# SMALL ARROW ENGINEERING, LLC

## EMW Public Access CNG Station Moriarty, New Mexico Addendum Number 1

Date: September 2, 2020  
Issued to: All Bid Document Holders of Record

**Section 00300B – Bid Item 3**

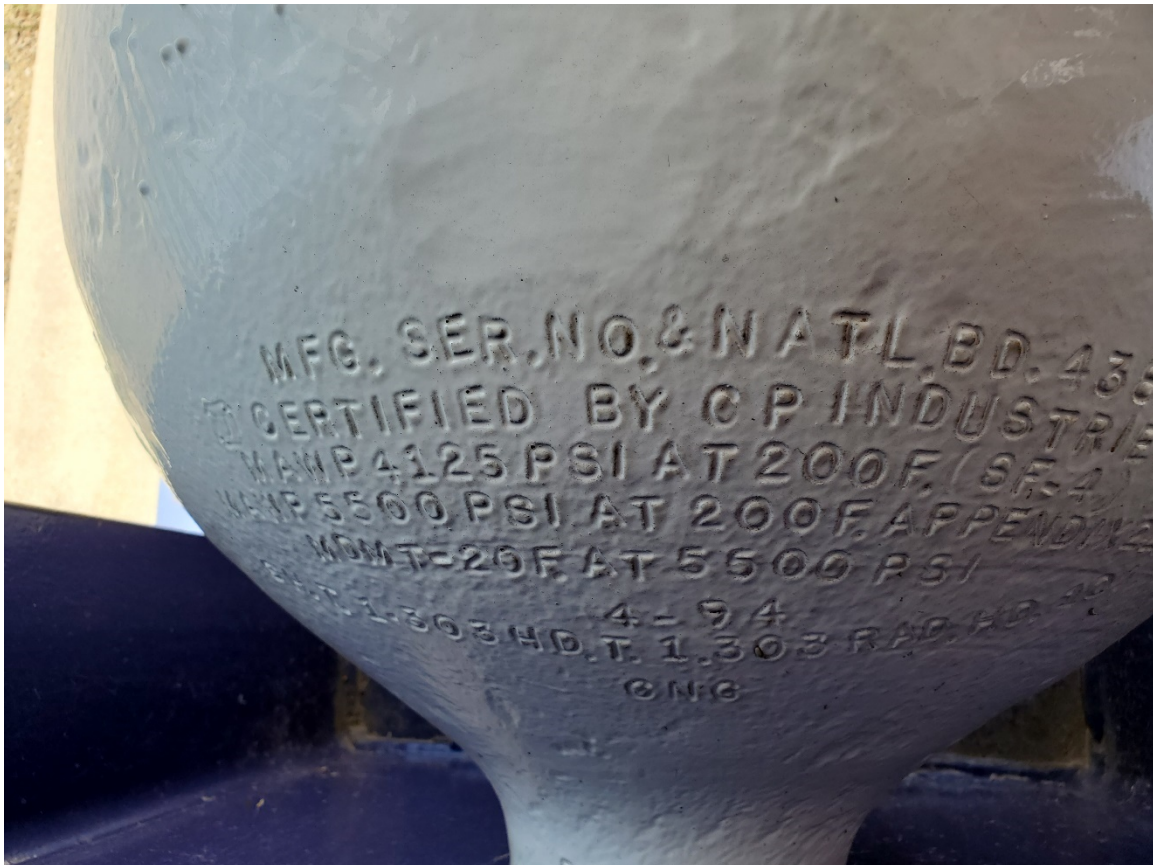
1. Reconditioning CNG storage Cylinders. These were not on site for inspection. Please provide direction on exactly what needs to be done to recondition these units. **EMW will transport the vessels to the Moriarty Shop for the Contractor to refurbish. The vessels will need to be sandblasted and painted with matching colors of JW sphere skids. The vessels will also need new relief valves installed with 3 year certification for 5500 psi setting.**
2. Are pictures available? **YES, see attached below: (And digital images are available upon request.)**

**Section 00300B – Bid Item 10**

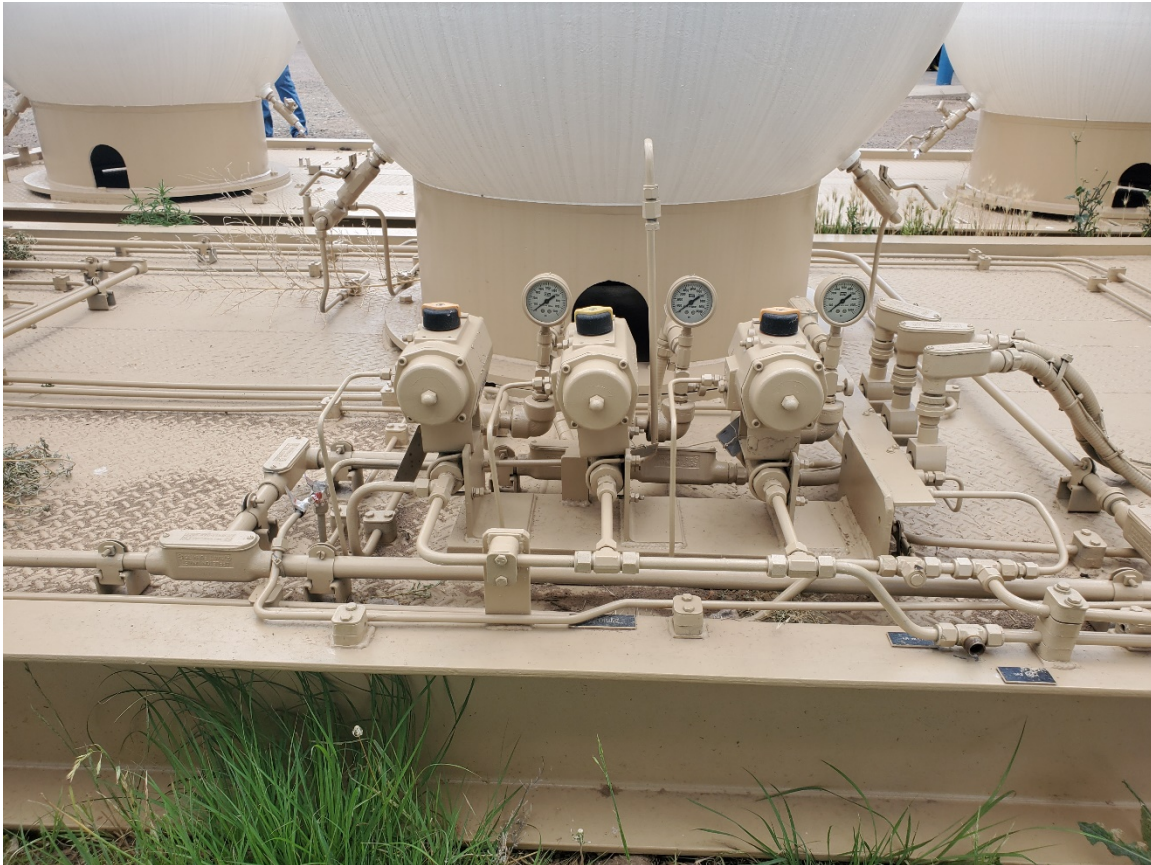
1. Please provide additional information regarding “rebuild” of Skid priority panel. **The Contractor will need to reassemble the priority panel system located on the JW sphere skid as per the original JW Power plans using existing components and adding new components to make a fully functional 3 bank cascade system. Each of the vessels from the other skids will need to be connected and tied into the priority system with valves isolating each of the vessel groups. The final bank count will be as follows: High Bank – One (1), Mid Bank – Two (2), Low Bank – Nine (9).**
2. See attached Photos of the priority system on the skid and the original STORAGE excerpt from the manufacturer.
